## ASSESSMENT REPORT

### Section 75W Modification Western Sydney Stadium Concept Proposal and Stage 1 (SSD 7534 MOD 2)

**Figure 4: Site Survey Plan – Omitted Lot** (source: Applicant)

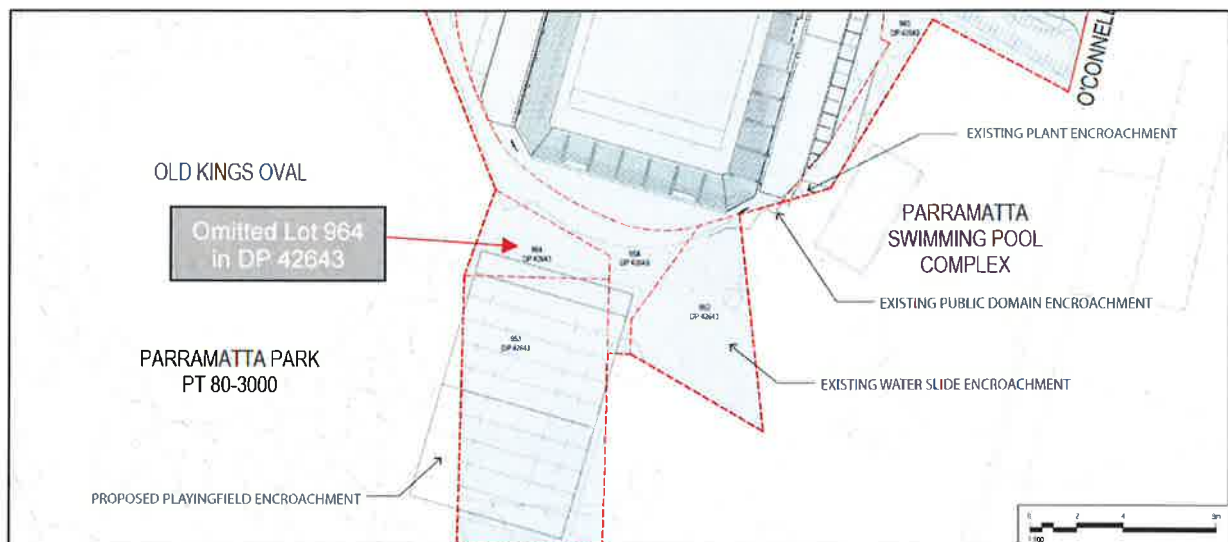
Lot 694 in DP 42643 (as shown in **Figure 4** above) was omitted in error the Applicant's Environmental Impact Statement (EIS) for SSD 7534. The omission was subsequently carried through to the land description in Schedule 1 of the development consent for SSD 7534, resulting in Lot 964 being unintentionally omitted.

The Department raises no objection to the proposed inclusion of Lot 964 into the description, acknowledging it will correct an administrative error.

**Figure 5: Revised Site Boundary (existing boundary shown black dashed)** (source: Applicant)

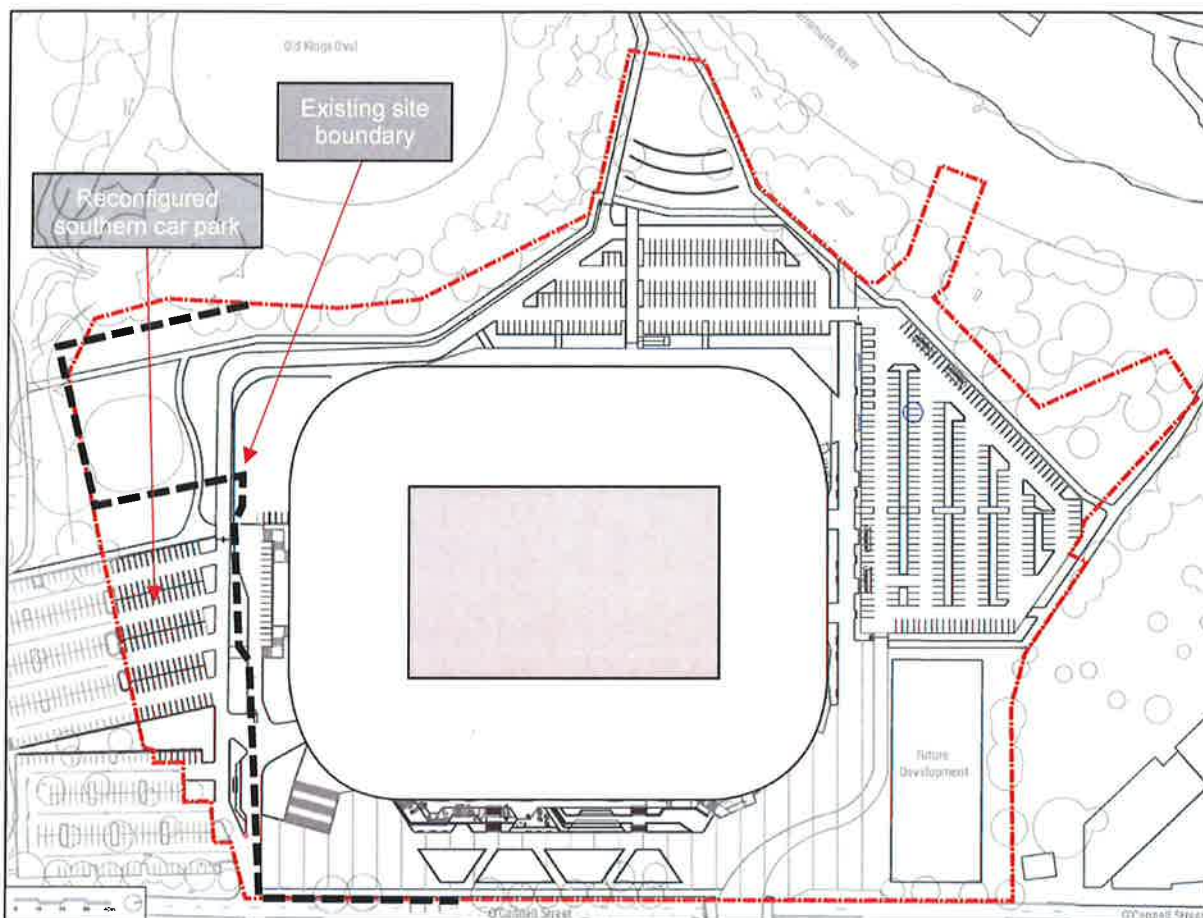
The modification application seeks to amend the southern development site boundary to facilitate future works in the southern commuter car park, including its reconfiguration and resurfacing and associated landscaping. The proposed amendments also seek to ensure consistency between the concept proposal and works proposed as part of SSD 8175 for the Stage 2 detailed design and construction of the Western Sydney Stadium.

The Department acknowledges the likely disturbance of the northern edge of the existing car park associated with stadium construction works and agrees the proposed reconfiguration of

On this basis, the Department raises no objections to the proposed amended southern development site boundary, noting the inclusion of the area within the revised development site boundary will facilitate improvements to the southern commuter car park and its interface with the adjoining Western Sydney Stadium.
